# New Hampshire Yankee

NYN-91079

May 16, 1991

Subject: Supplement to Request for License Amendment - Residual Heat Removal System Isolation Valve Autoclosure Interlock Removal

FIGURE 1

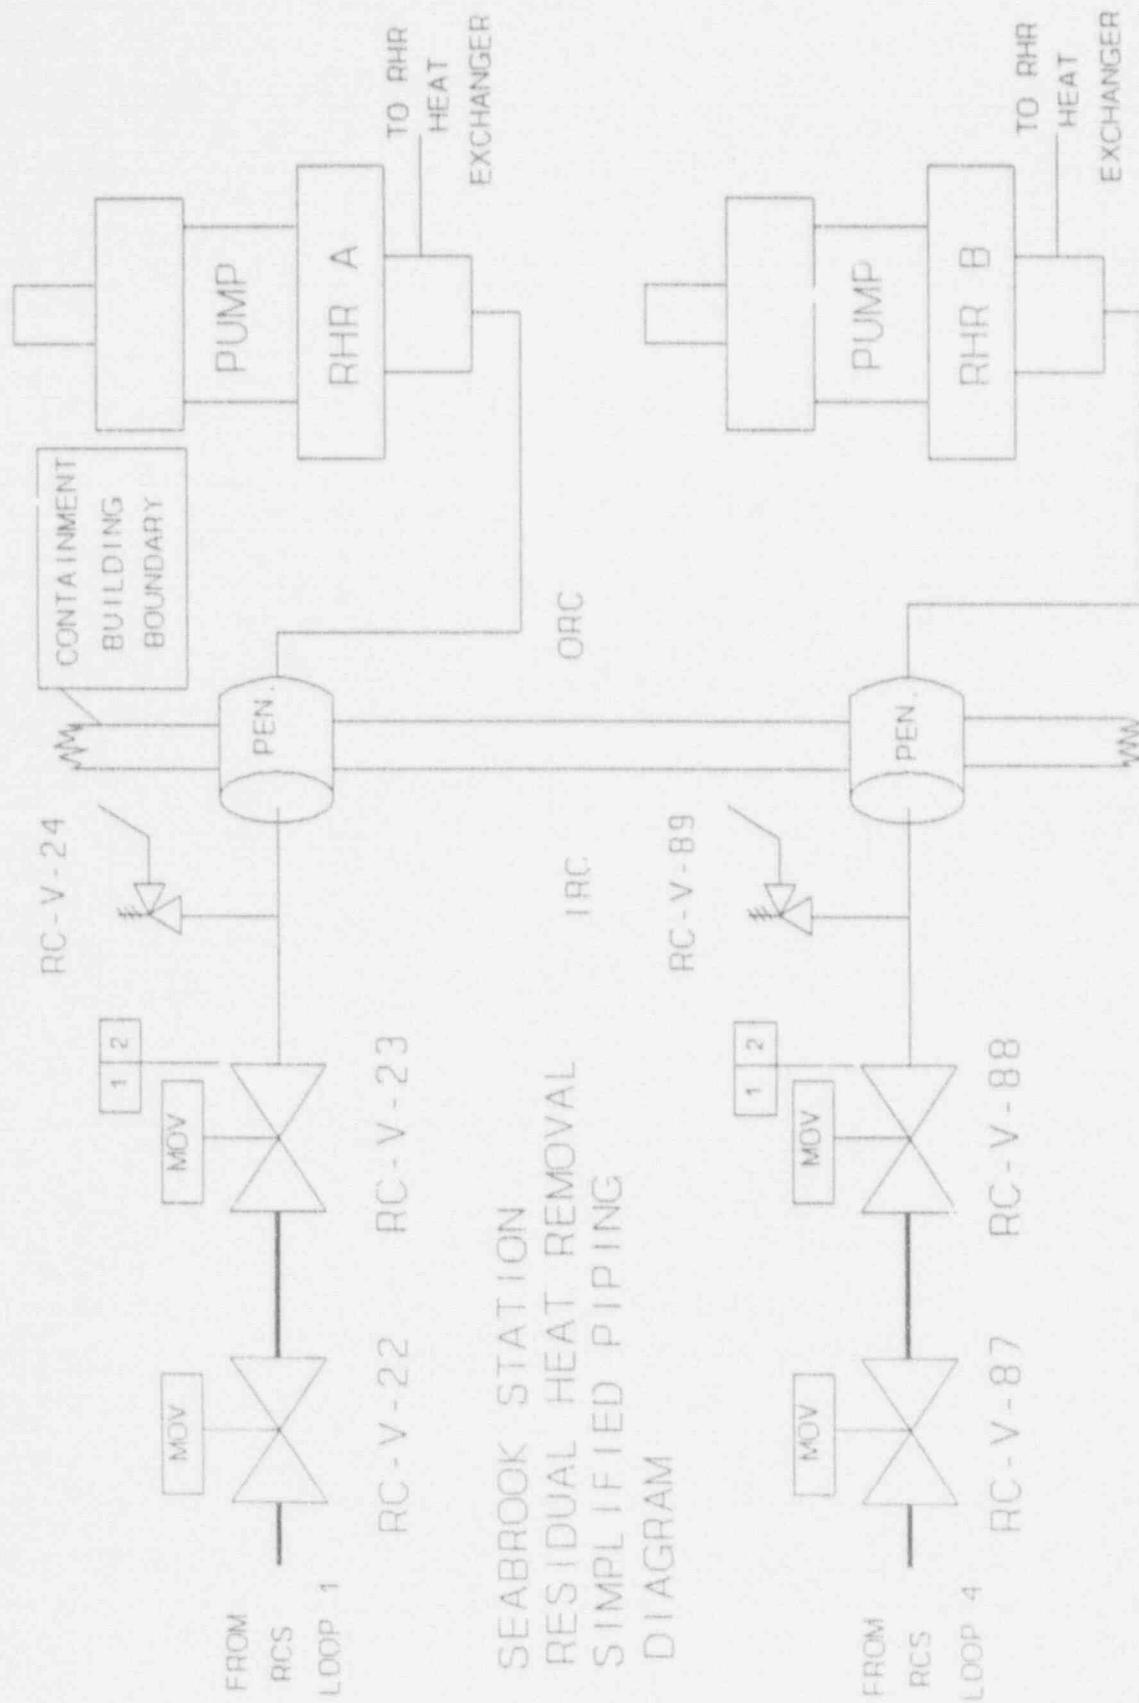
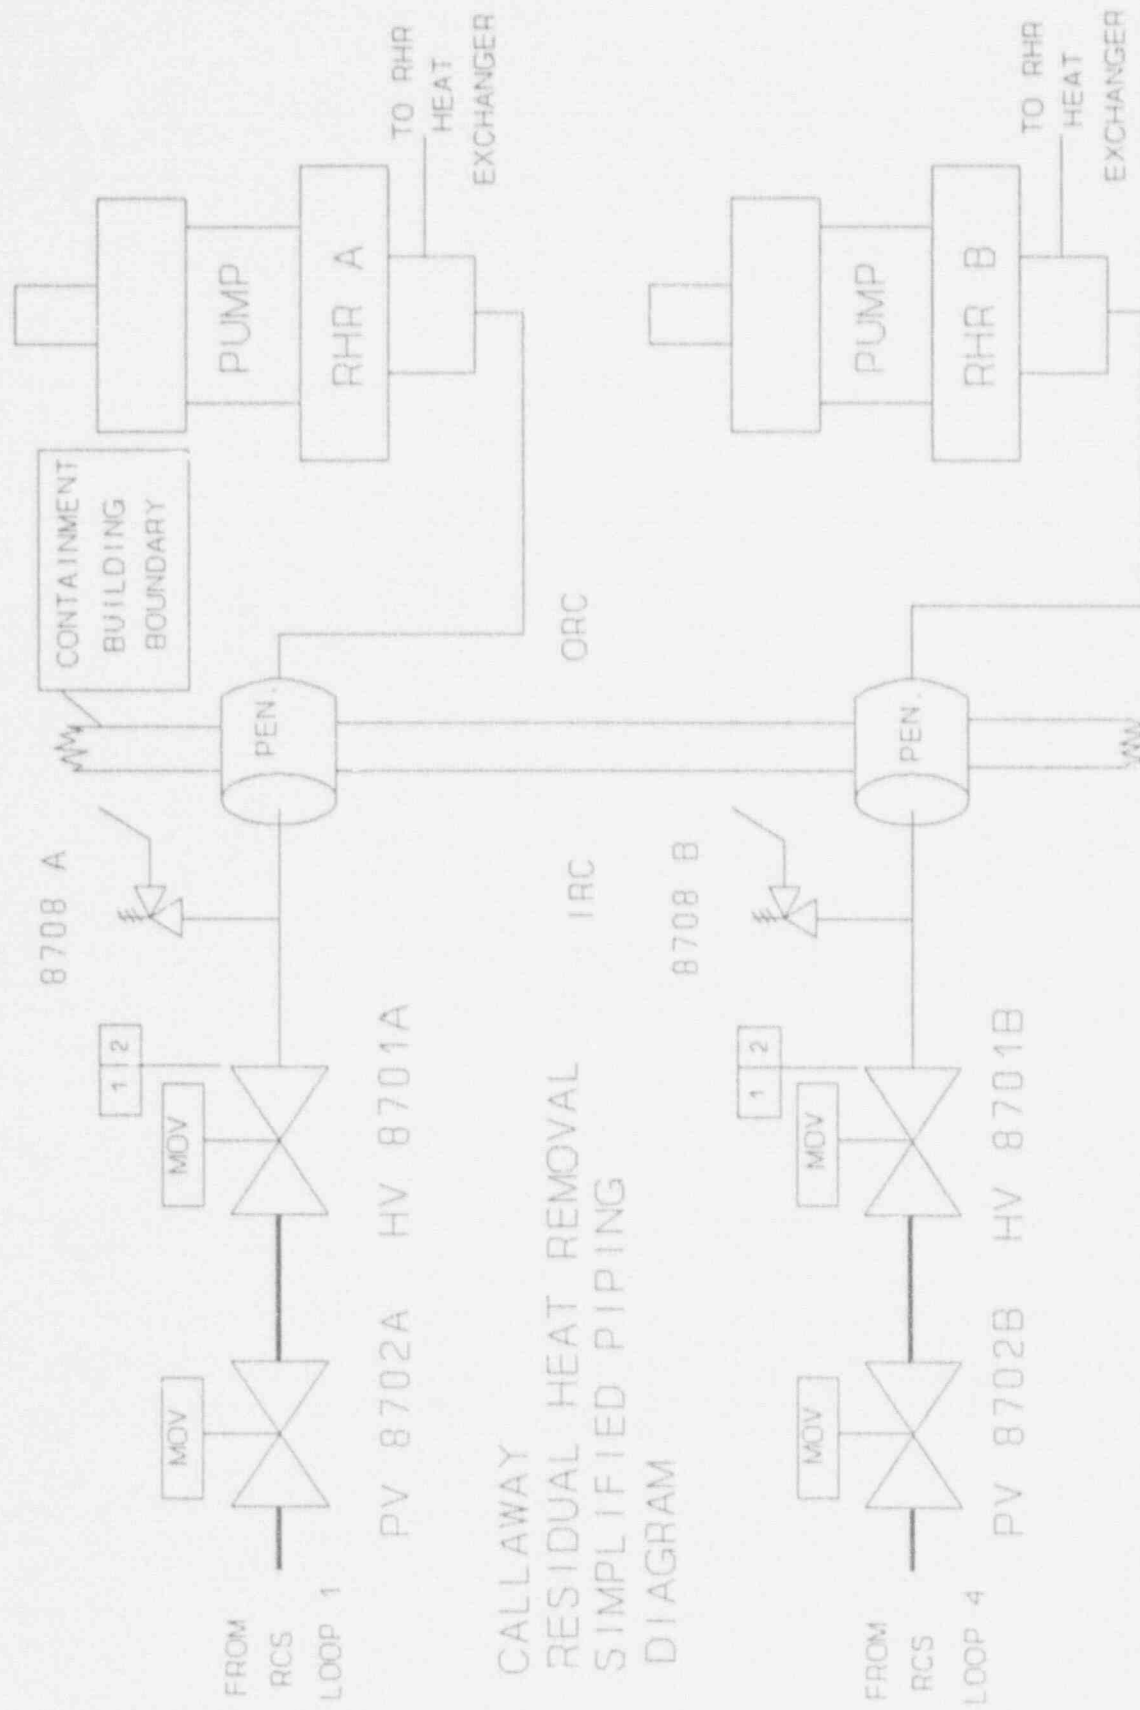
The Seabrook Station RHR inlet isolation valves are located inside the containment and are Safety Class 1. The code class break occurs after the second isolation valve and prior to the RHR suction relief valve which is also located inside the containment. The Seabrook design is very similar to that of the Callaway plant. Simplified diagrams showing the Seabrook and Callaway configurations are provided as Figures 1 and 2 respectively.

FIGURE 3

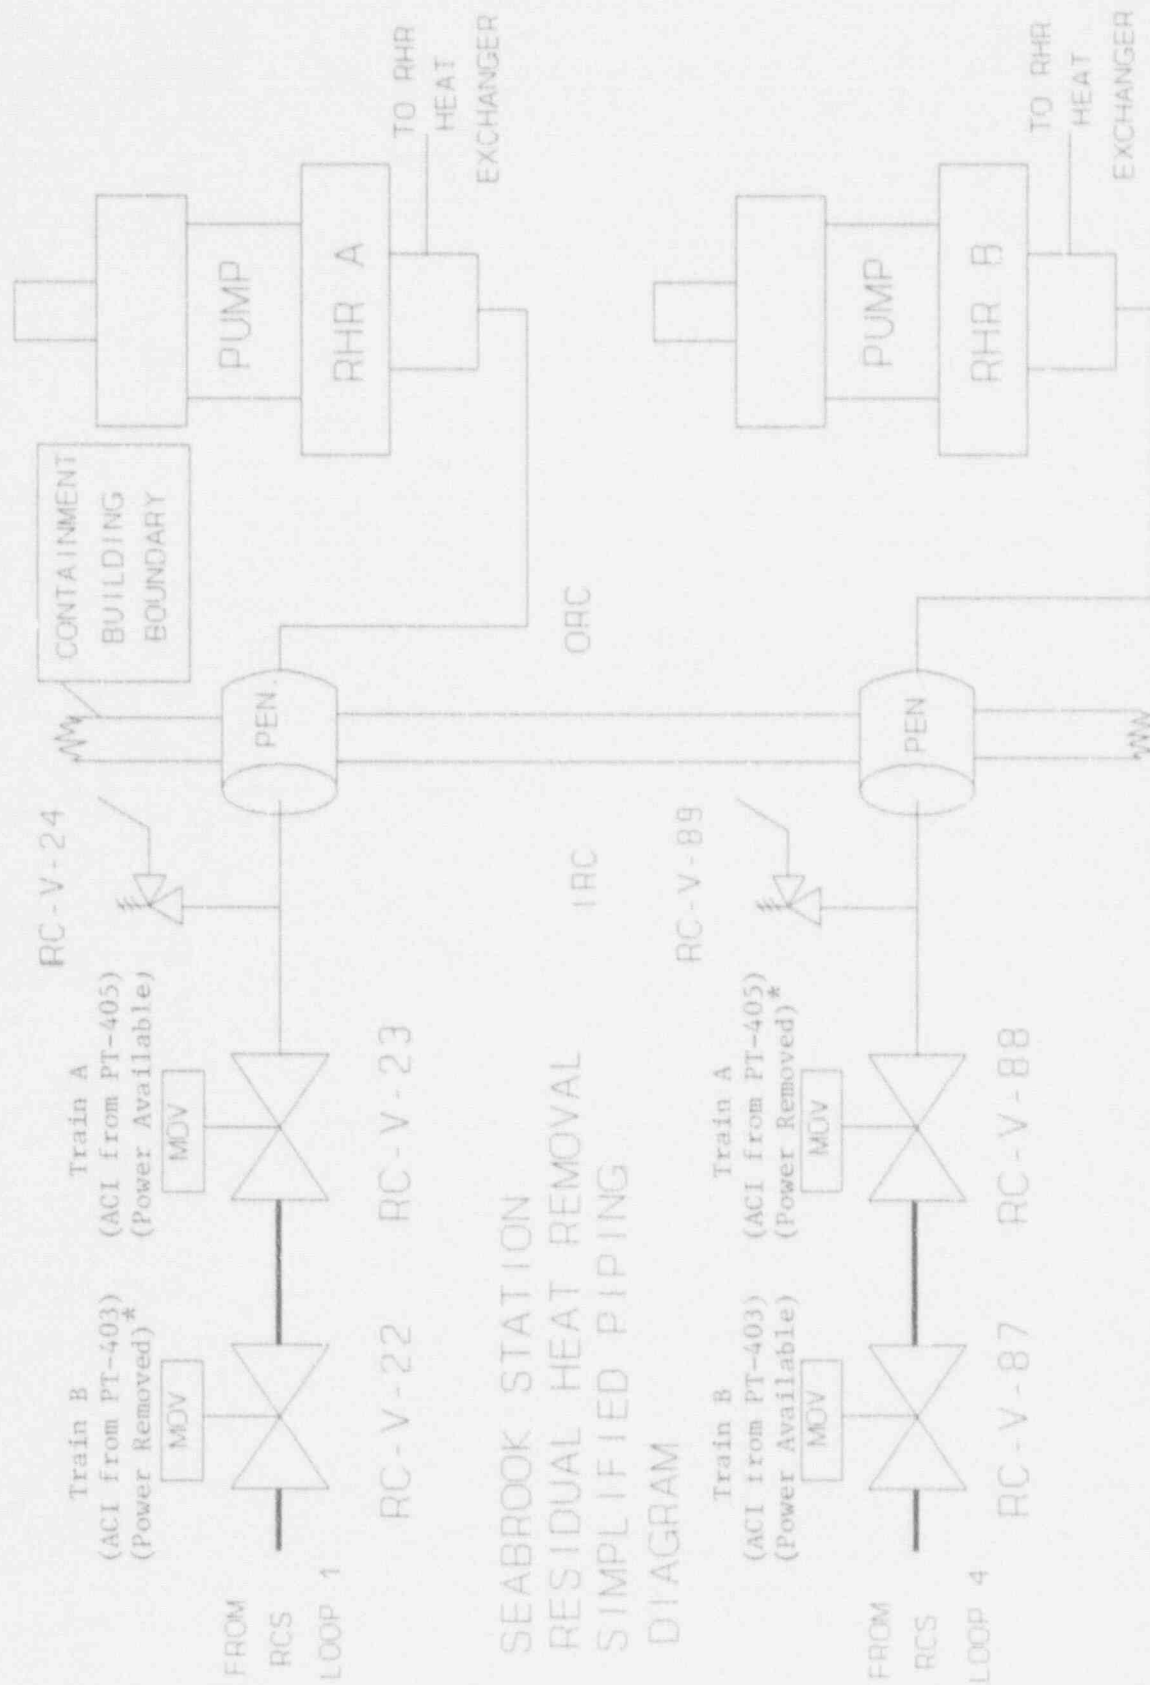
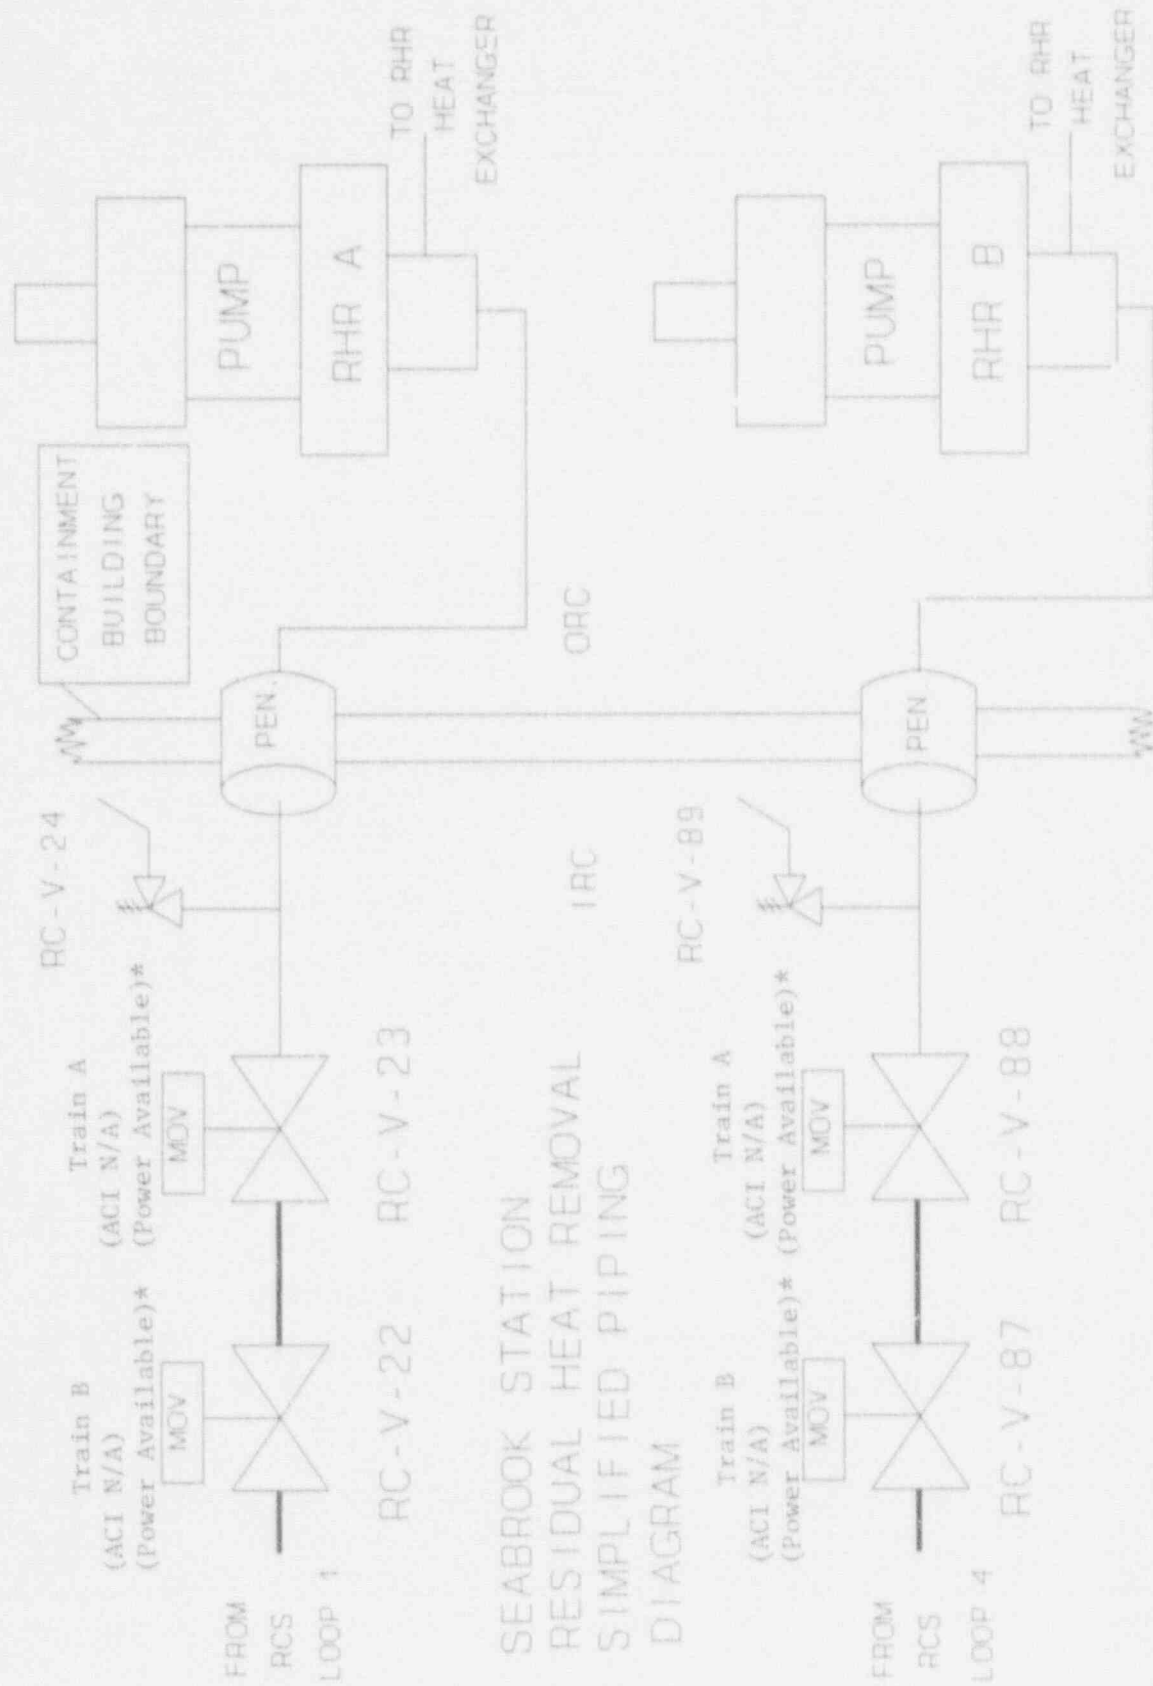
The current TS SR 4.4.9.3.2 requires a verification that power is removed from RC-V88 and RC-V22. The current requirement to verify power is removed ensures that a single failure of the common pressure transmitter PT-403 for RC-V22 and RC-V87 or the common pressure transmitter PT-405 for RC-V23 and RC-V88 does not result in both trains of RHR being isolated from the RCS (see Figure 3).

The proposed TS SR 4.4.9.3.2 does not require the removal of power from any of the RHR suction valves. With the disabling of the RHR Autoclosure Interlock (ACI) circuitry there is no mechanism for autoclosure of the RHR suction isolation valves which can result in both RHR trains being isolated from the RCS (see Figure 4) and concomitant loss of RHR cooling.

\*Power is removed from RC-V-22 and RC-V-88 per Technical Specification 4.4.9.3.2

to preclude isolation of both RHR trains in the event that either PT-403 or PT-405 fails and generates a spurious closure signal to both RHR trains.

\*Power is available to RC-V-22, RC-V-23, RC-V-87, and RC-V-88. With the disabling of the ACI circuitry there is no single failure which can cause both RHR trains to isolate.

(Before ACI Removal)

(After ACI Removal)
